Office Action Summary	Application No. 10/656,653	Applicant(s) COOK, DANIEL J.	
	Examiner Darwin P. Erez	Art Unit 3773

DETAILED ACTION

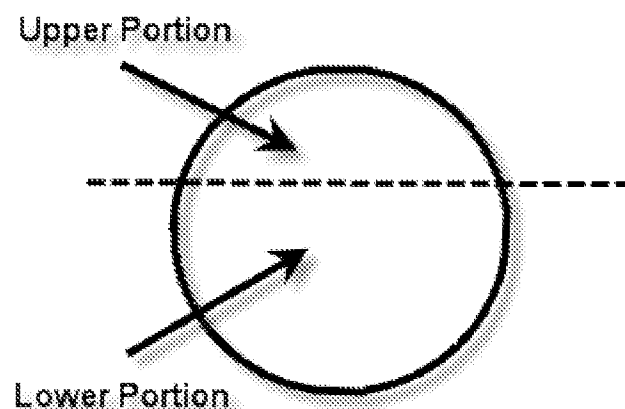
Brain further discloses a laryngeal mask having a distal lumen, wherein the distal lumen is a circular lumen, which can have an upper portion and a lower portion, and which is still smaller than the diameter of the tube adapter at the proximal end. The distal lumen can be divided into asymmetrical halves so that the upper portion can have a diameter that is different from the lower portion. See figure below.

The applicant's argument that Brain fails to teach the limitations of claim 43 is not persuasive because the claim does not specifically recite a "keyhole". Instead, the claim merely recites a lumen having an upper portion and a lower portion. As seen above, a circular lumen can be sectioned off to an upper portion and a lower portion, wherein the upper portion has a diameter that is different from the lower portion.
